Review of EPA's RFS2 Lifecycle Emissions Analysis for Corn Ethanol

For:

Renewable Fuels Association (RFA)

Date: September 22, 2009

Figure 3-1

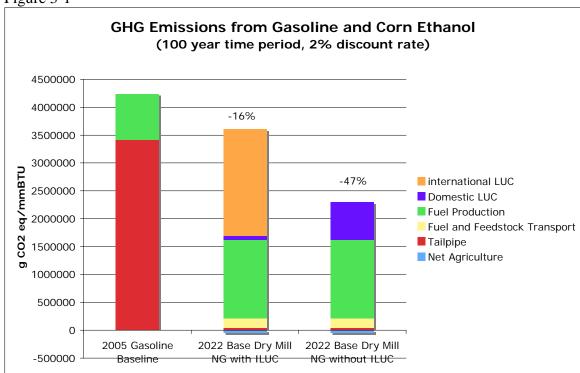
The figure shows that with EPA's mix of domestic and international land use changes, corn ethanol achieves a 16% reduction from 2005 gasoline. For corn ethanol, the international land use changes comprise the largest single category of emissions. In the third bar, we show that if all or nearly all of the land changes occurring were to occur in the U.S. at the same emissions rate as the 0.3 million acres, *and the remainder of the EPA*

modeling is correct, corn ethanol may achieve up to a 47% reduction. Clearly, it is critical to examine the land use changes that EPA has estimated in detail.

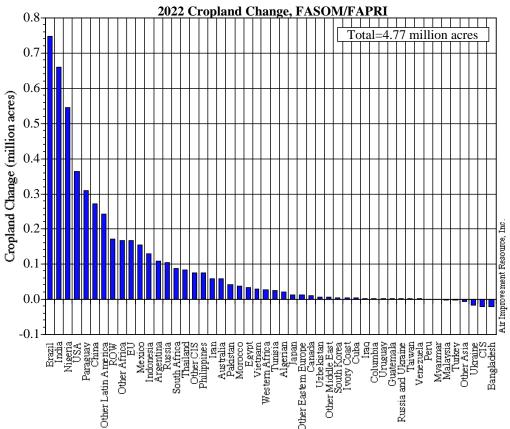
Figure 4-1 shows that the top 6 areas with predicted land use changes are Brazil, India, Nigeria, the U.S., Paraguay, and China. As indicated earlier, all the non-U.S. land changes are generated by FAPRI, and the U.S. land changes come from FASOM. Since the RFS-2 is a U.S. control program, the implication of all the international land use changes in this analysis for the control program reflects that there is little or no land available in the U.S to absorb this control program without a large impact on exports and world commodity prices. As will be shown later in this report, this is simply not true, and the land use databases and the models' use of these databases in both FASOM and FAPRI for the U.S. need to be critically reviewed and revised (among other changes that are also needed).

Figure 2.6-16.

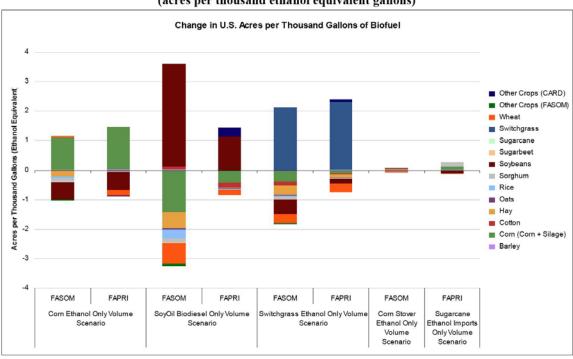
EPA's basis for this statement is that the two bars at the far left appear similar. However, this figure only shows the plusses and minuses of crop changes per thousand gallons of ethanol, and it does not show the net crop changes, or the total new crop acreage. As noted in the Background, for the corn only scenario, FASOM predicts that 0.3 million acres of new cropland are needed in the U.S. However, FAPRI predicts that 1.46 million acres of new cropland are needed in the U.S. Therefore, FAPRI predicts *almost 5 times the amount* of cropland is needed in the U.S. than FASOM.

The fact that FAPRI shows greater cropland is needed in the U.S. than FASOM also illustrates a tendency for the FAPRI model to over-predict land use change. This raises another important, fundamental question with regard to a domestic policy to increase biofuels: which model predicts domestic land use changes better – FASOM or FAPRI? We presume that EPA believes FASOM predicts domestic land use changes better, otherwise, we assume EPA would have used FAPRI for all land use change estimates. If EPA favors FASOM domestically, and if FAPRI strays far from FASOM with regard to exports, prices, and domestic land use change, then FAPRI should be re-calibrated to FASOM or not used at all.

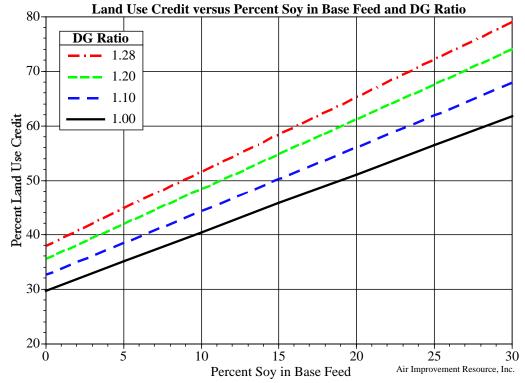
Figure 4-2, developed by AIR, predicts a 50% land use credit with these parameters (lb for lb, with 19% soybean meal), which is higher than 45% developed by Fabiosa. The difference in land use credits between AIR and Fabiosa is due to the Fabiosa approach accounting for the loss of soy oil when the soy meal is substituted away. AIR agrees with this adjustment, thus, Figure 4-2 probably overstates the land use credit by about 5 percentage points. However, if the Fabiosa approach were utilized with all livestock and poultry (not just swine), and all of these results were combined, it is likely that the overall land use credit of DDGs would be in the 66-69% range (5 percentage points less than the 71-74% range shown in Table 4-2), which is still much higher than the 36-39% range currently utilized by FASOM and FAPRI.

EPA must either update the DG land use credits for corn ethanol for all livestock and poultry types in FAPRI and FASOM for the final rule, or explain in detail why the Argonne, Shurson, AIR, and Fabiosa analyses are in error.

Figure 4-3

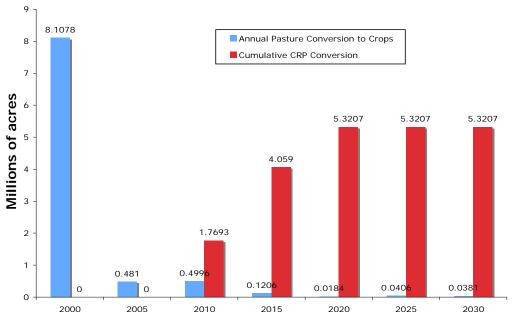
The limitation that no more than 10% of pastureland can be converted to cropland over the period of analysis is limiting conversion of land to cropland in the U.S., and thereby transferring these conversions overseas where the emission impact is higher due to lower yields and denser, unmanaged forests. For example, Figure 4-3 shows pasture converted to crop over the period of analysis of the EISA FASOM analysis, and also shows the cumulative CRP conversion over the same period. The plot shows significant pasture conversion to crops in calendar year 2000, and after that the conversion of pasture to cropland is miniscule. CRP land gets converted in between 2010 and 2020, but these conversions level out because of the assumption that CRP land will not dip below 32 million acres. As a result, FASOM assumes there is very little land available in the U.S. for conversion to crops to support the RFS2 volumes.

EPA needs to explain in detail the technical basis for the 10% assumption, the uncertainty involved in this assumption and the impacts of this assumption on U.S. versus non-U.S. conversion and land use emissions for at least the corn-only case, if not all the other cases involving the use of U.S. land.

Figure 4-4

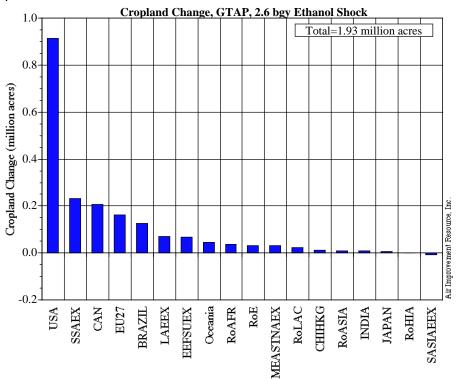
-0.5. ²¹ The land use changes by country are shown in Figure 4-4 below. These land use changes represent either pasture or forest converted to cropland, and not cropland switching. Forty-five percent of the predicted land use changes occur in the U.S., demonstrating a completely different result from the 5% or so from the U.S. predicted by EPA's combined FASOM/FAPRI analysis. Furthermore, this GTAP run shows 1.9 million acres being converted for the 2.6 bgy, instead of EPA's 4.7 million acres.
